STATE OF VERMONT AGENCY OF TRANSPORTATION			
Town Of	SEARSBURG	Bridge No.	25
Highway No.	VT. RTE. 9	Log Sta.	
		Surv. Sta.	
VT. RTE. 9 OVER DEERFIELD RIVER			
APPROACH SLAB DETAILS - BR 25			
Designed By	D. VIENI	Drawn by	K. DETRICK/Wm WEATHERBY
Checked By	M. OLSTAD	Bridge Design Supervisor	M. OLSTAD
Date	2/2002	Date	2/2002
PROJECT	SEARSBURG - WILMINGTON	PROJECT NO.	NHF 010-(18)
I.G.C. Info.		Bridge Sheet No. BR210	
		Sheet 136 OF 435

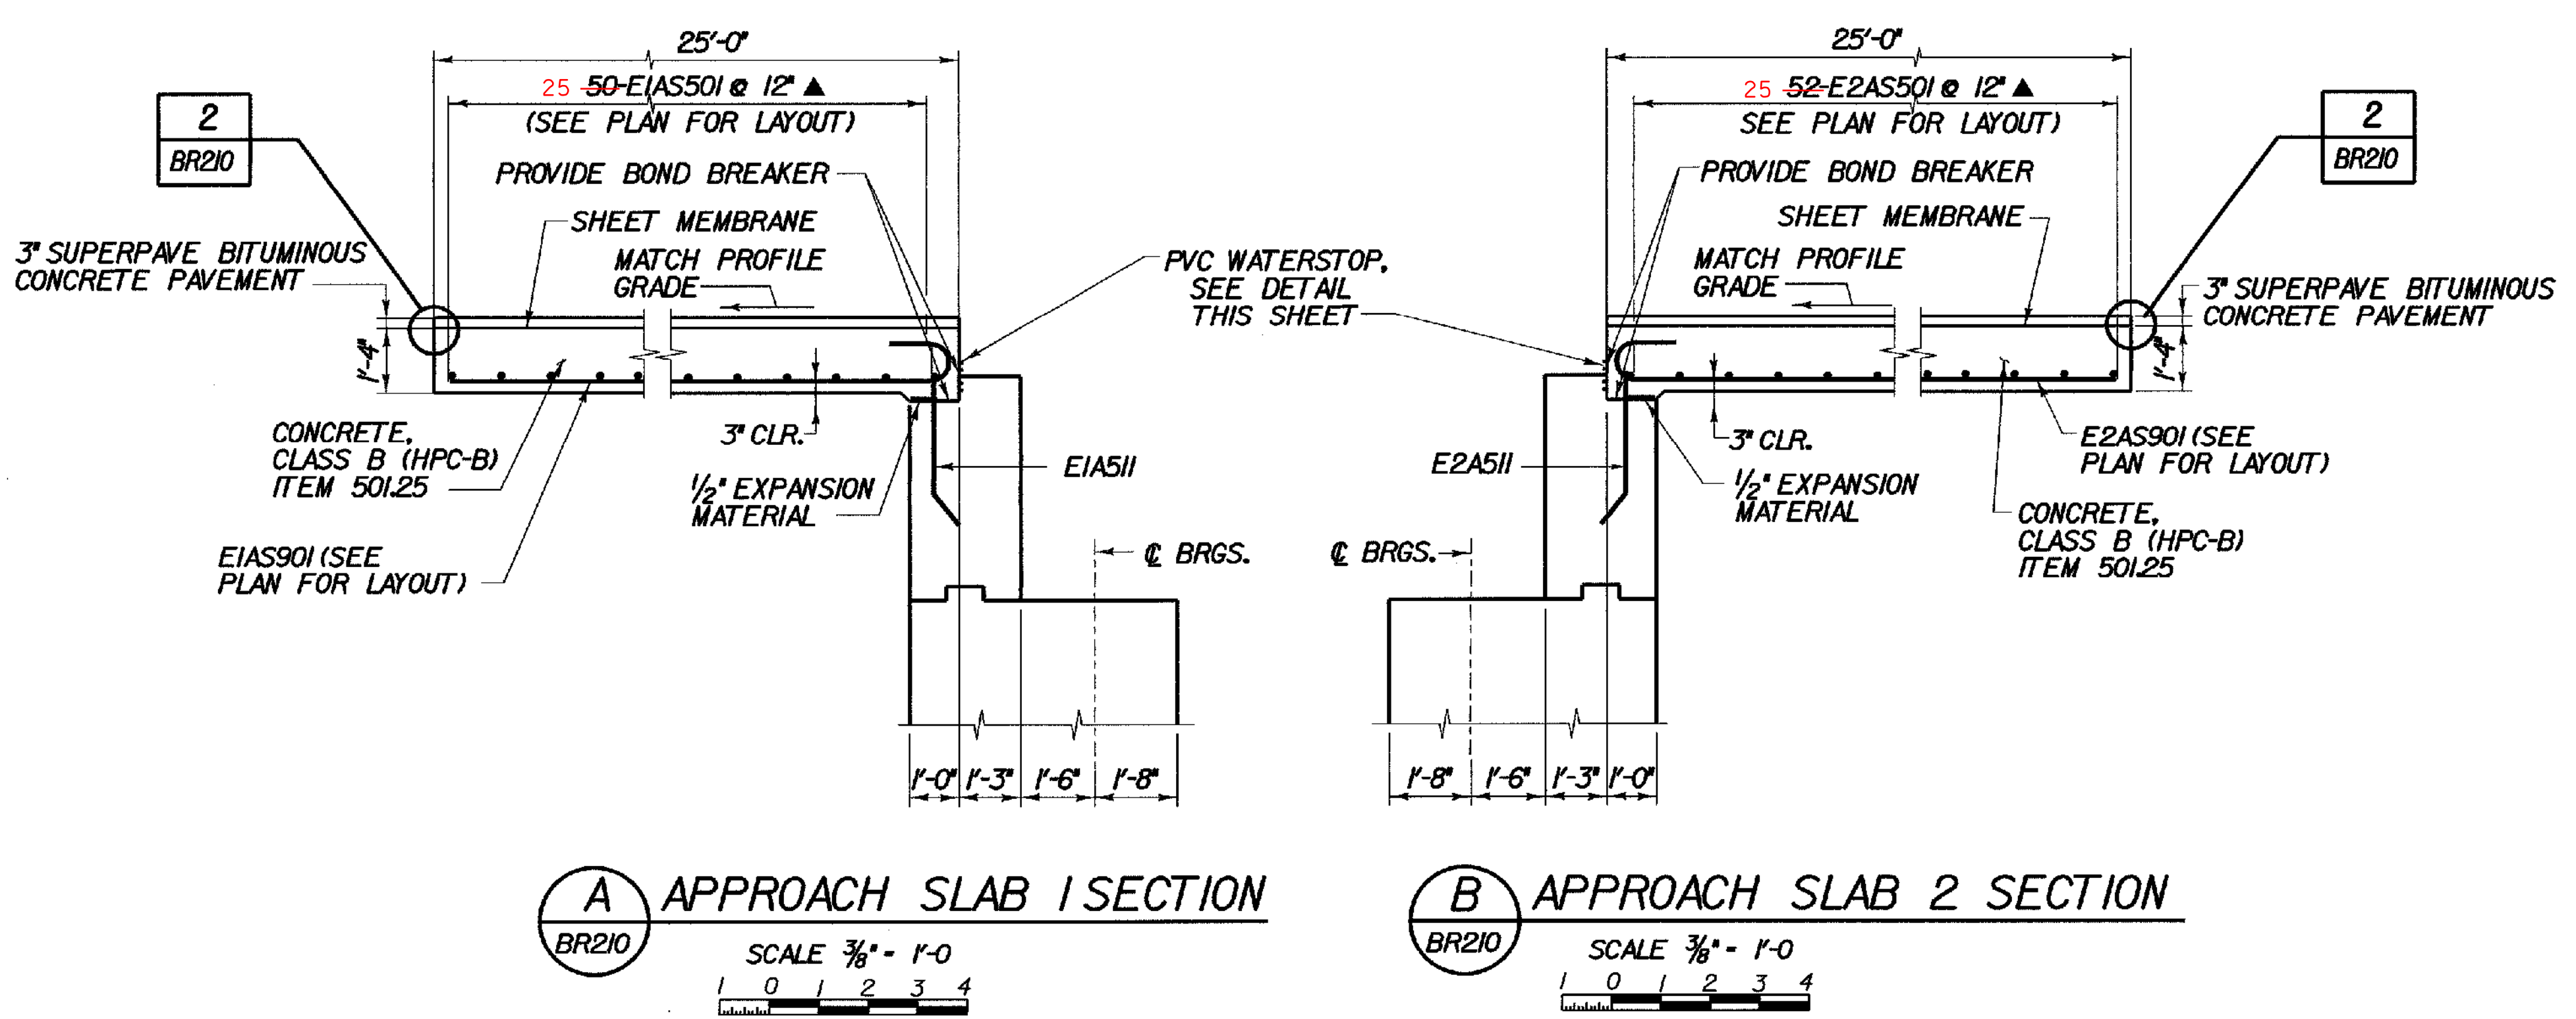
PER RE IGNORE SUBBASE TRANSITION AND RUN SUBBASE UP TO ABUTMENT 4'-0" FROM F.G. DOWN. NO SAND BEING USED, JUST SUBBASE.
